VAG Group

ERRM1108, ERRM1109 and ERRM1110

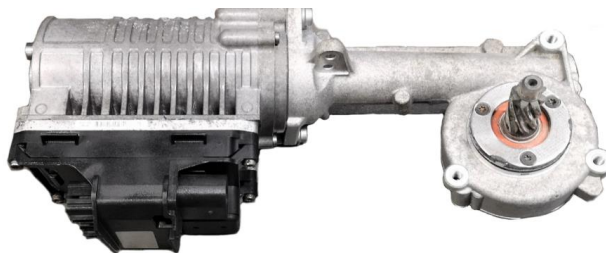
The OE generation 1 and 2 steering racks have been discontinued by the OEM. This leaves the latest OE numbers which are for the generation 3 steering rack only.

The latest number will cross reference to ERRM1110. This could be incorrect for pre 2009 vehicles.

Please see the information below to identify which steering rack is fitted to the vehicle:

Generation	Date From	Date To	Number of Rack Mounting Holes
1 (ERRM1108)	2003	2004	4
2 (ERRM1109)	2004	2009	4
3 (ERRM1110)	2009	Onwards	3
